FAX TRANSMISSION COVER SHEET

Re: Groundwater Investigation - 670 98th Avenue, Oakland

PROPOSED SAMPLING LOCATIONS

Figure 3

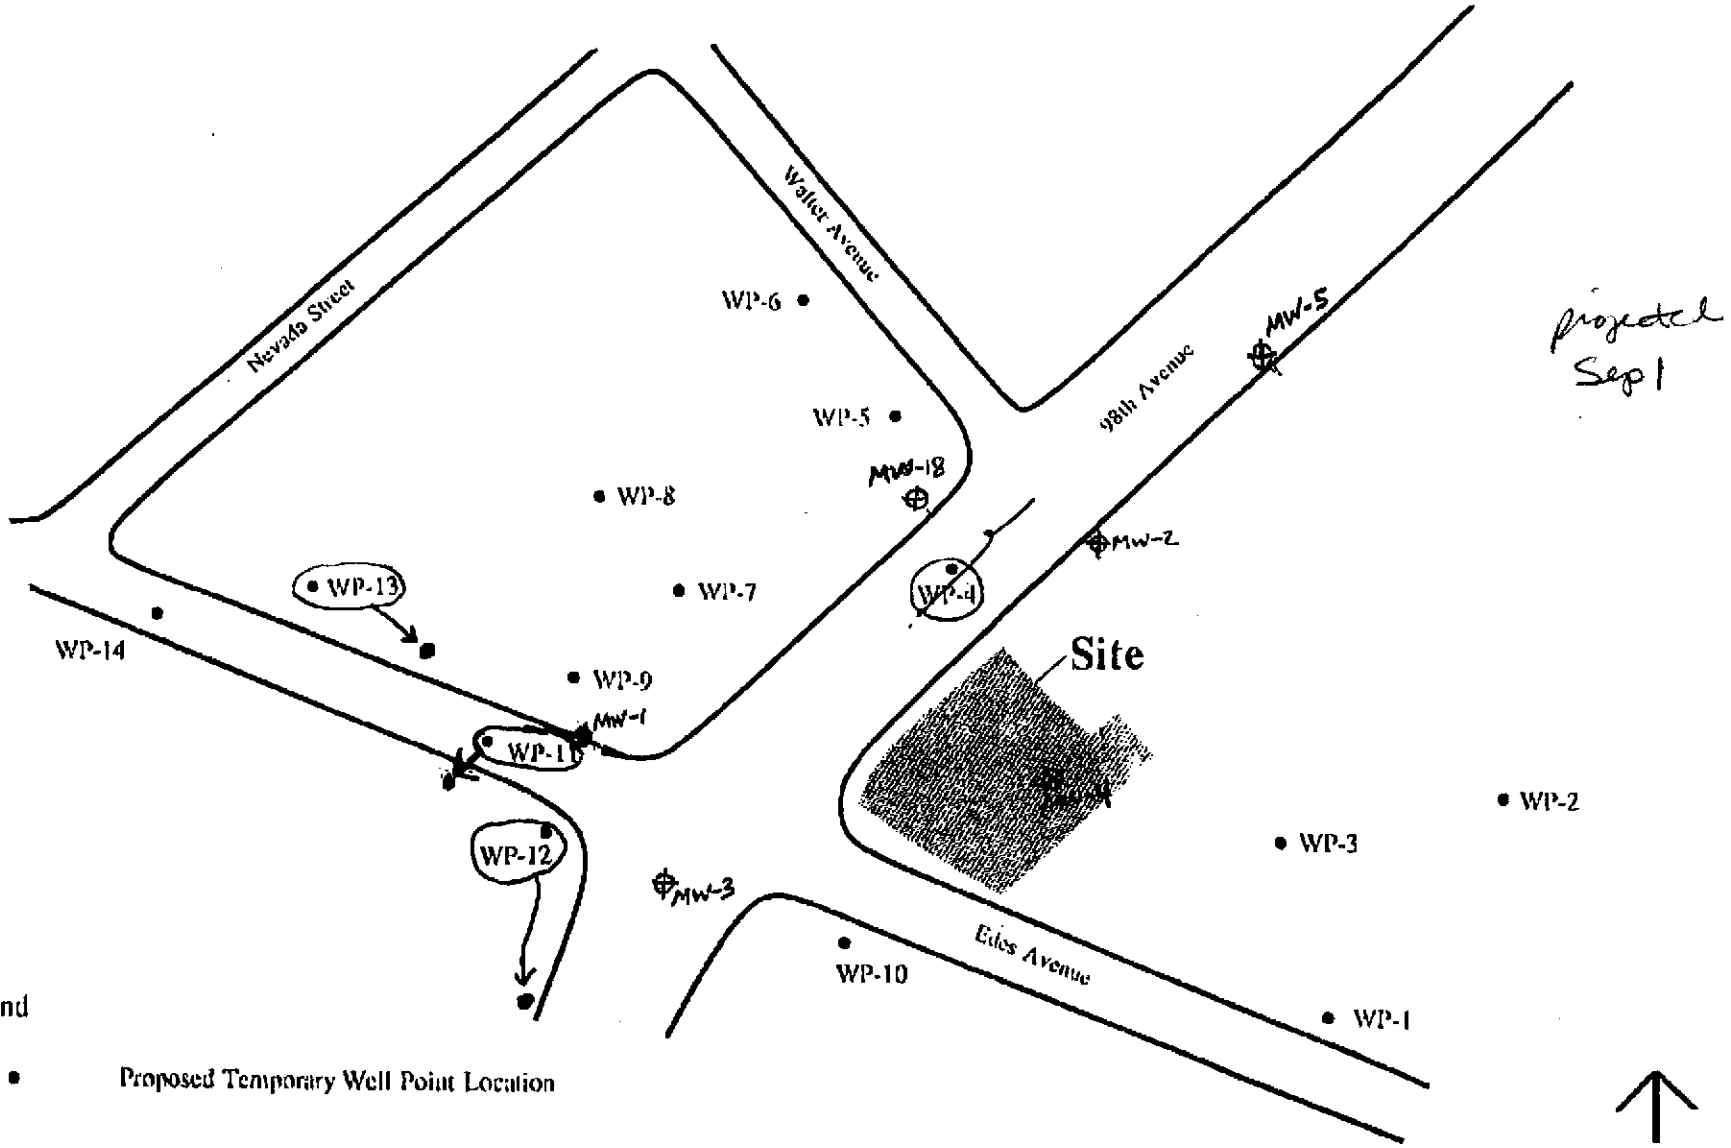
Attached for your review is a map of the subject site showing the existing monitoring wells, the locations of the temporary well points as originally planned, and the proposed changes to these locations. The proposed changes are as follows:

- move WP-12 to the south to obtain better coverage of the area to the southwest of the site and the consistent concentrations of TPH that have been found in MW-3;
- move WP-11 to the south because its current location is close to MW-1 thereby providing somewhat redundant data and because moving it will fill a gap resulting from moving WP-12;
- moving WP-13 to the east will provide for easier access in the vacant lot where WP-7, -8, and -9 are located rather than in the driveway of a church (its current location);
- eliminate WP-4, located in 98th Avenue because its location is redundant to MW-18.
